ADDENDUM NO. 1

TO: Interested Parties
FROM: Jessica Spring, Project Manager
Division of Engineering
DATE: Monday, June 6, 2022
PROJECT: Showalter Road at Crayton Boulevard Signal Intersection Improvements
County Contract No. TS-SC-040-16
Project No. 16-040

SHOWALTER ROAD AT CRAYTON BOULEVARD
SIGNAL INTERSECTION IMPROVEMENTS

COUNTY CONTRACT NO. TS-SC-040-16
PROJECT NO. 16-040

**SHOWALTER ROAD AND
CRAYTON BOULEVARD INTERSECTION
TRAFFIC SIGNAL
PLAN**

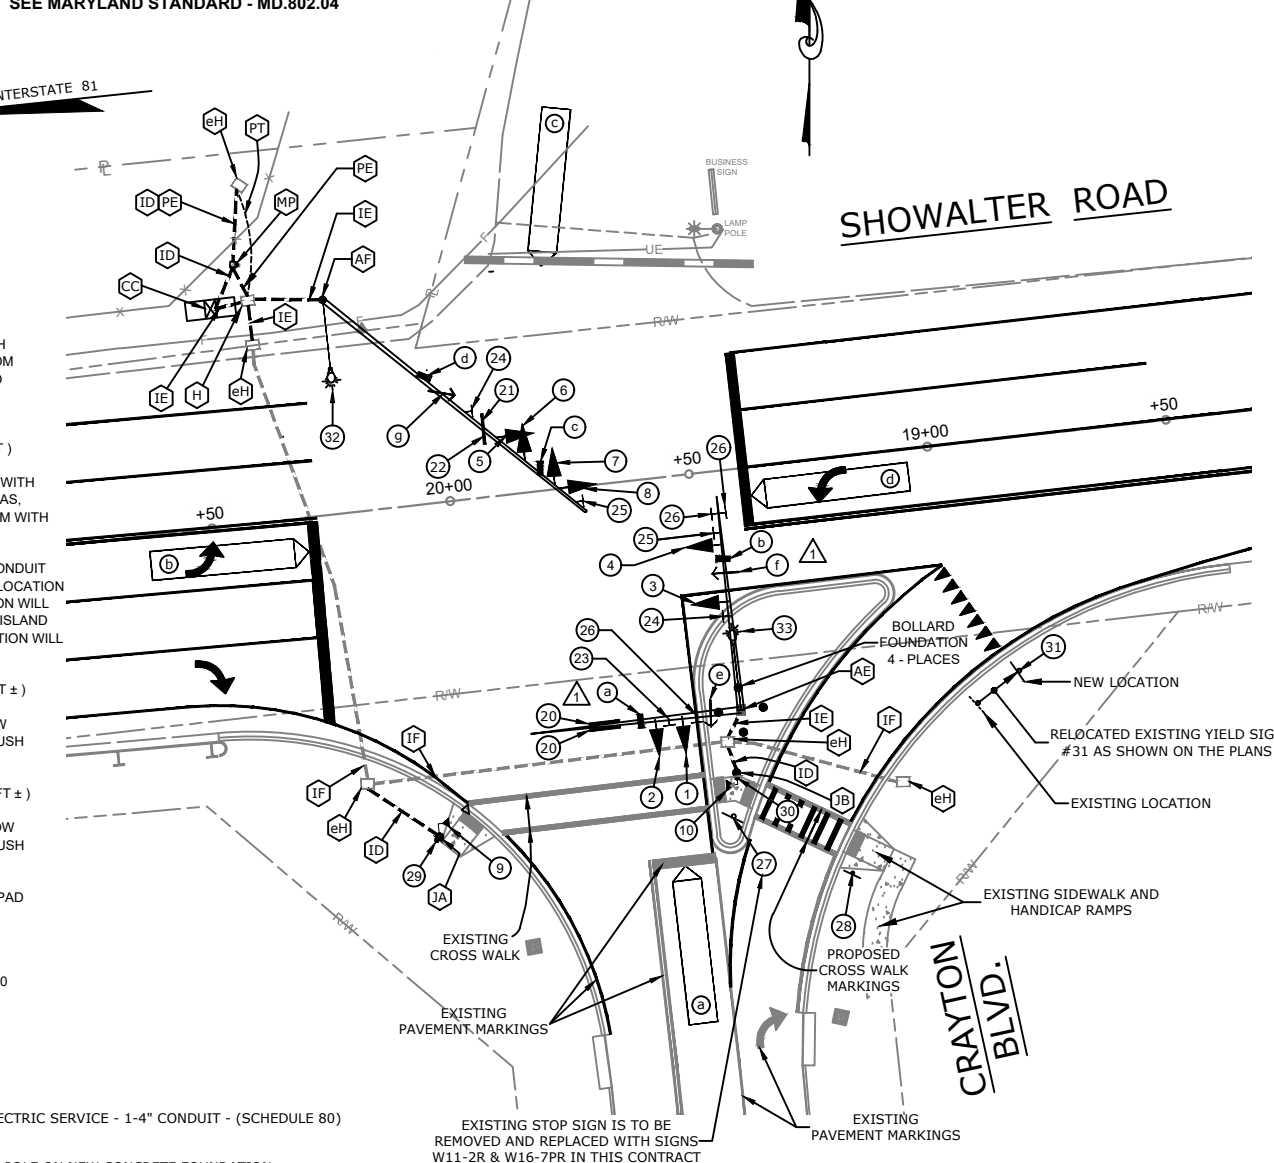
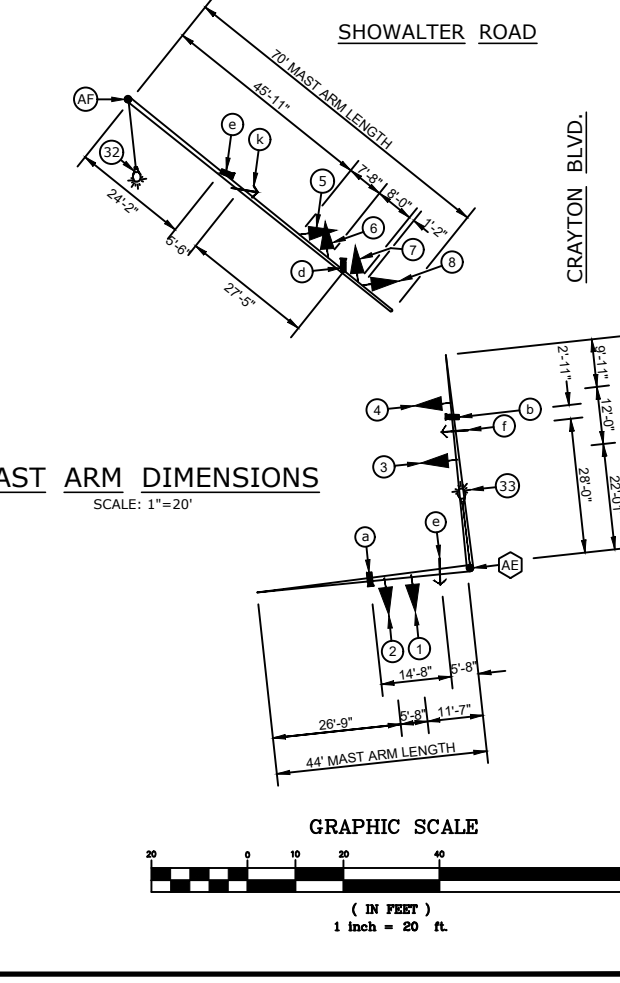
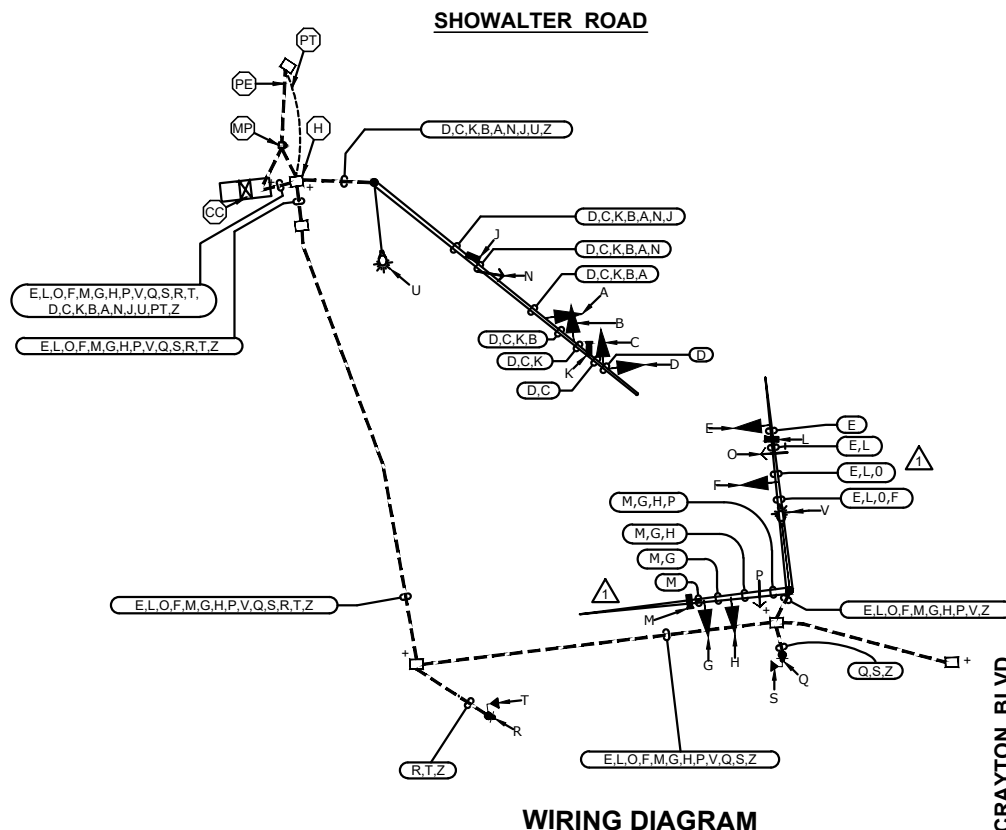
REPLACE previously issued project drawings (11 pages) with REVISED drawings (11 pages) included herein. Note, the revised bid documents include one each 27-foot steel pole with twin 44-foot mast arms. The new pole at the southeast quadrant of the intersection will utilize the existing 4-anchor bolt signal foundation per MDOT SHA's previous standard (Bid Item 8030). The other new pole (Bid Item 8031) located at the northwest quadrant of the intersection will utilize a 6-anchor bolt configuration.

NO.	REVISION DESCRIPTION	BY	DATE
1	MAST ARM - SEE CORNER TO A TWIN ARM DESIGN	GLJ	06-01-22

Project information including Washington County, Maryland, Division of Engineering, project name 'SHOWALTER ROAD AND CRAYTON BOULEVARD INTERSECTION MD-SHA STANDARD DETAILS', and sheet number '05 OF 11'.

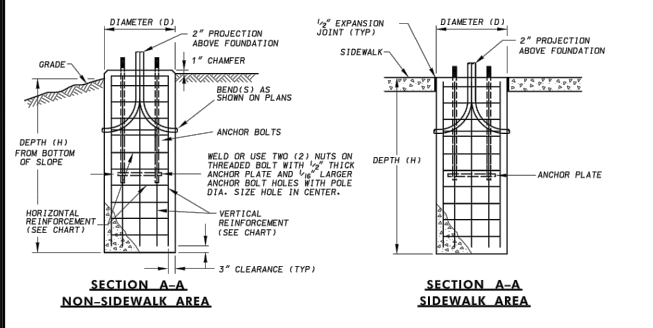
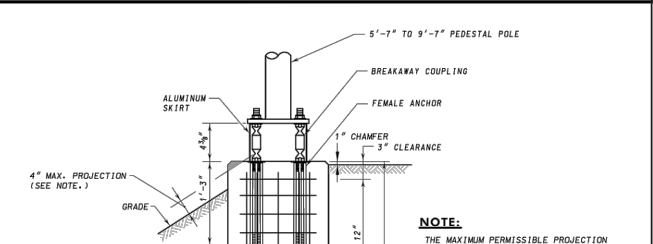
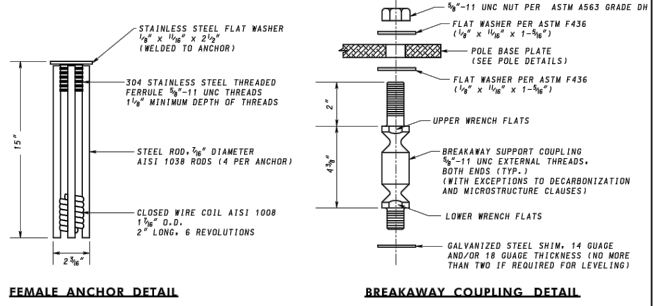
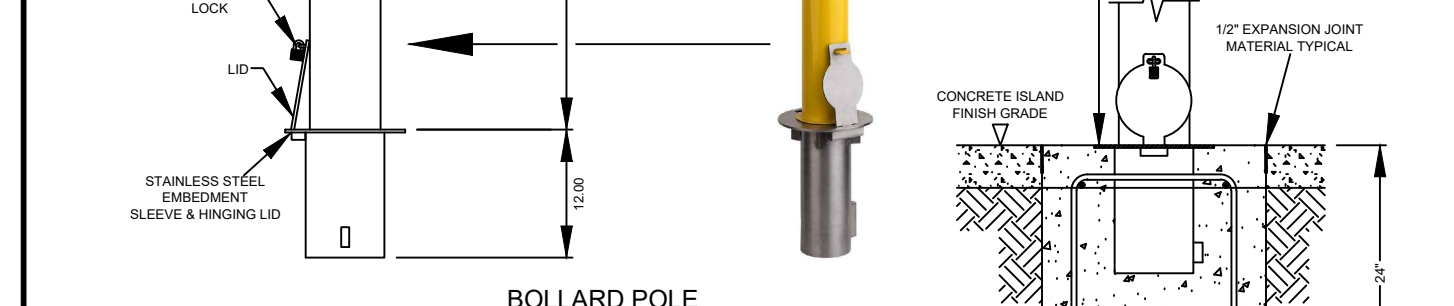
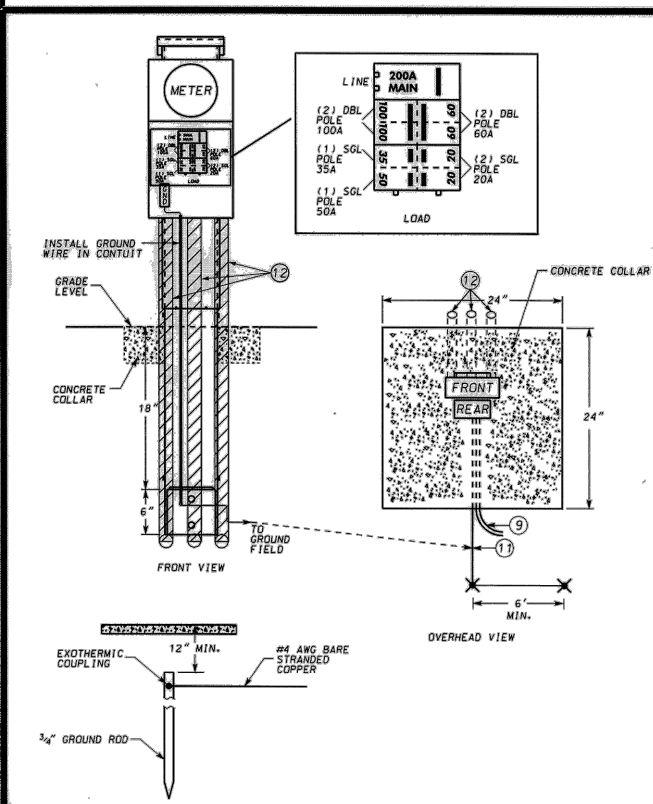
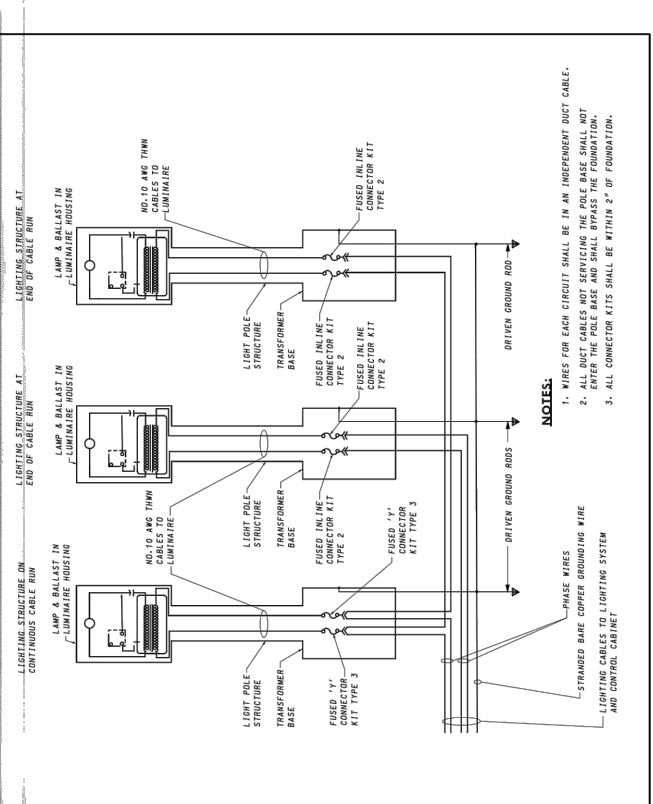
Q2: Existing 4-Anchor Bolt Signal Foundation at Southeast Quadrant: The existing signal foundation located in the concrete island at the southeast quadrant of the intersection has four (4) anchor bolts. The existing 4-anchor bolts are oriented 90-degrees to Showalter Road and not 45-degrees as shown on the drawing. I do not believe that the existing 4-bolt configuration with the orientation as shown will work with the proposed design. Please advise.

Note that the new/proposed signal foundation located at the northwest quadrant of the intersection shall be constructed with six (6) anchor bolts per the updated Maryland State Highway Administration Signal Structure Foundation detail provided in the project drawings.

SHOWALTER ROAD AND
CRAYTON BOULEVARD INTERSECTION
MD - SHA
STANDARD DETAILS

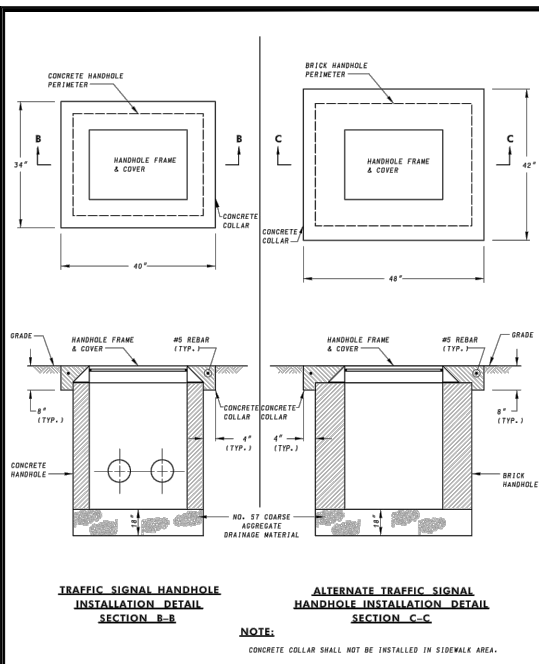
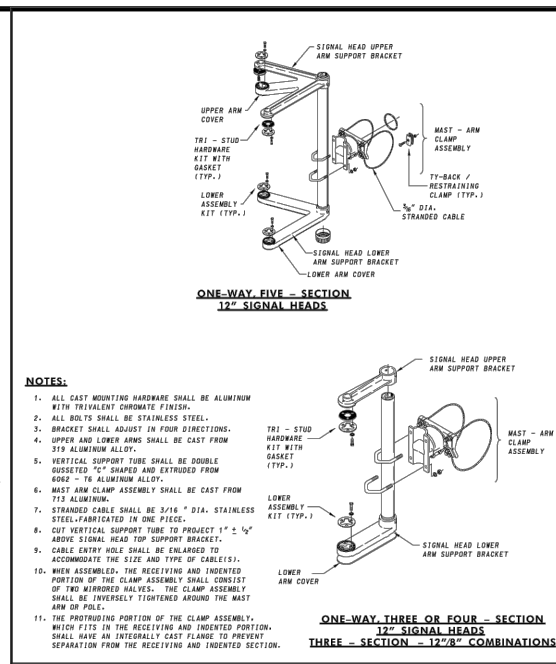
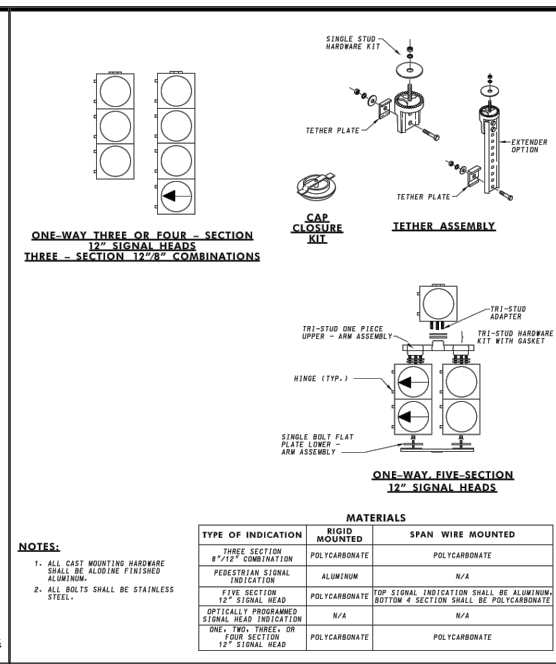
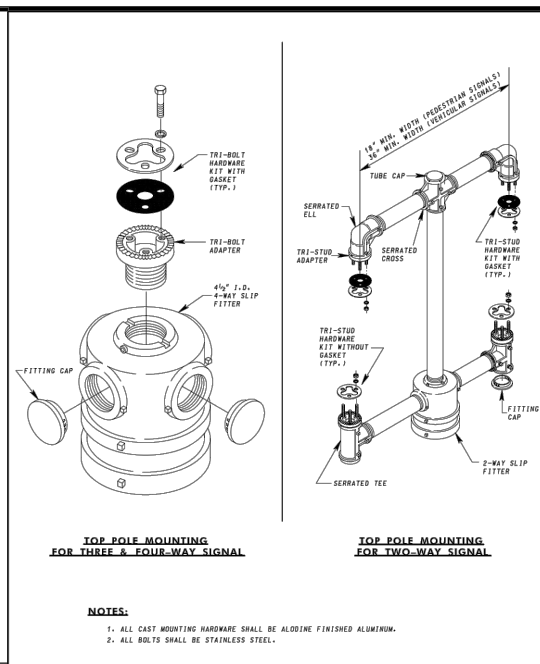
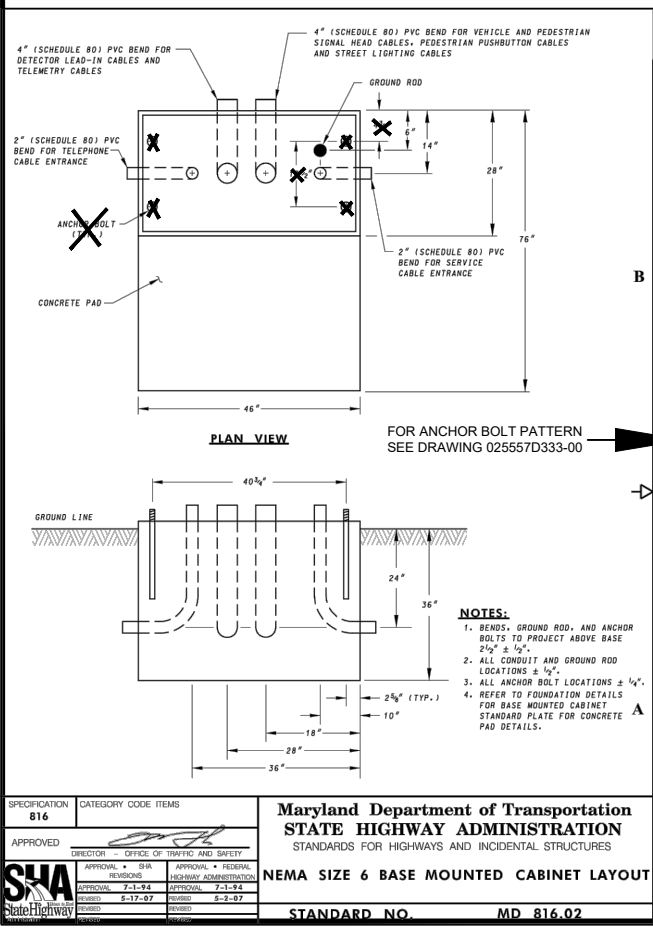
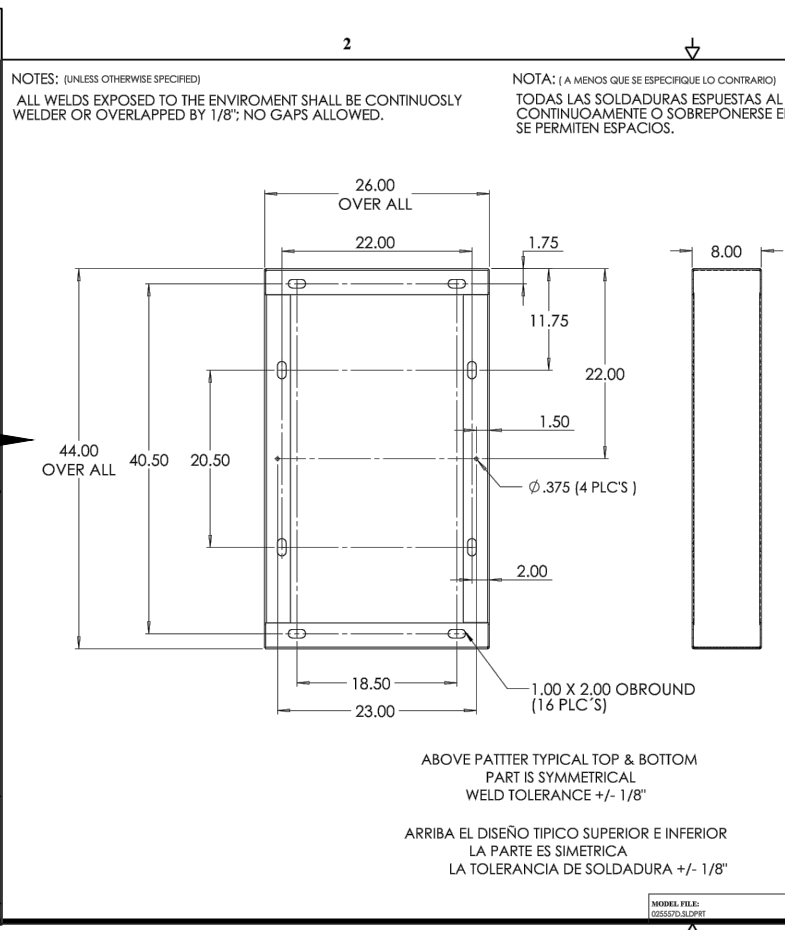
DATE	06-01-22
BY	GLJ
REVISION DESCRIPTION	ADD DETAIL MD-SHA 818.20
NO	1
DESIGNED BY:	SH / PJM
DRAWN BY:	GLJ
CHECKED BY:	PJM / TP
DATE:	05-17-22

SCALE: NONE
SHEET NO. 07 OF 11
PROJECT NO. 16 - 040

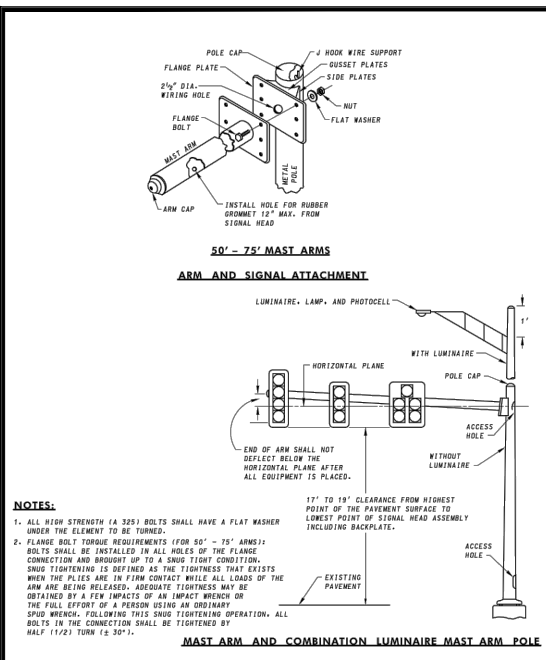
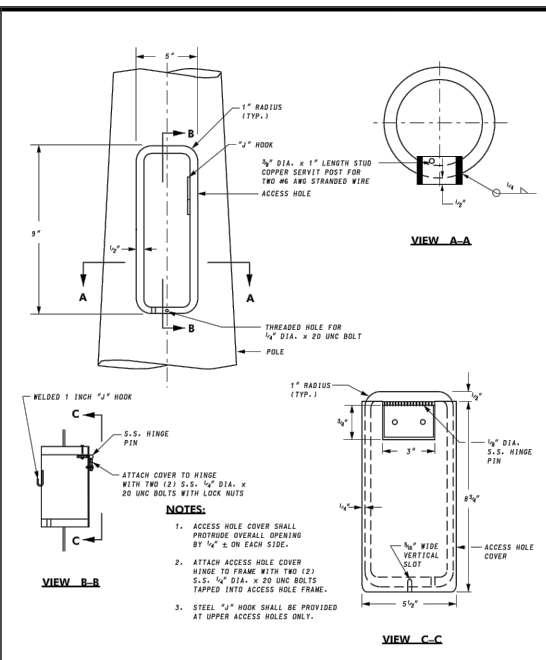
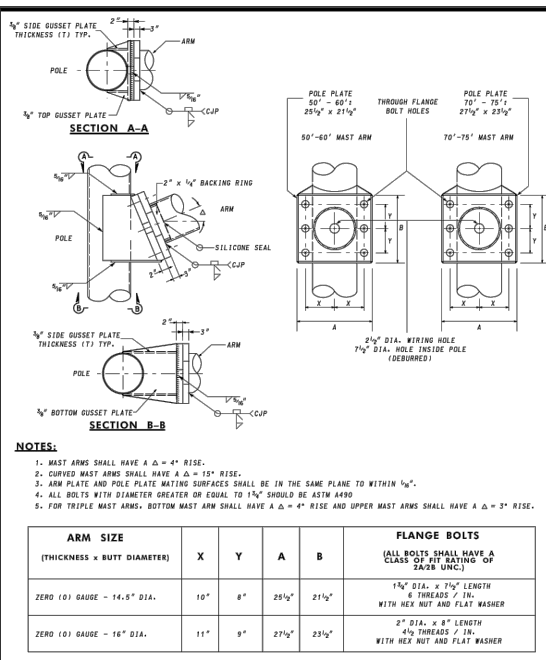
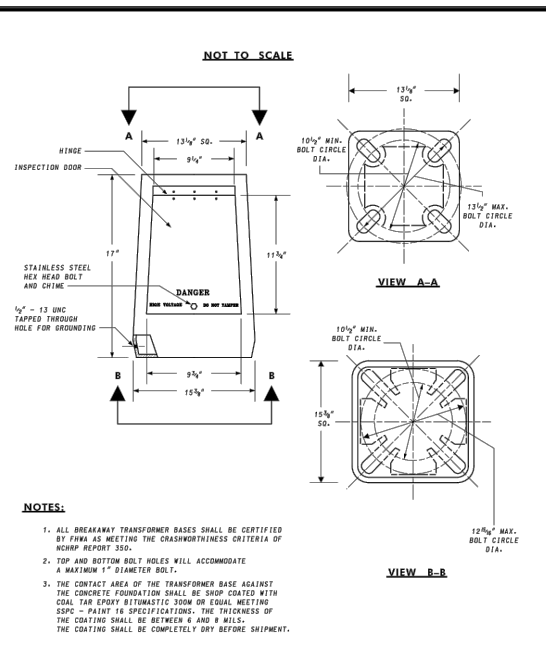
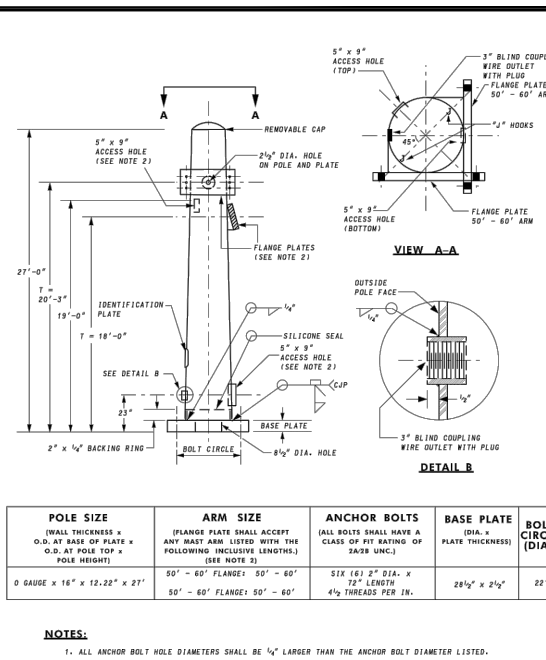
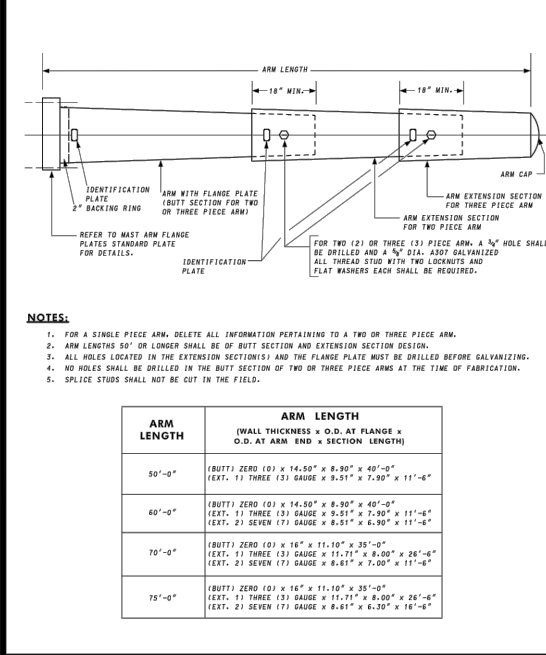
DATE: 06-01-22
BY: GLJ
REVISION DESCRIPTION: ADD DETAIL MD-SHA 818.07
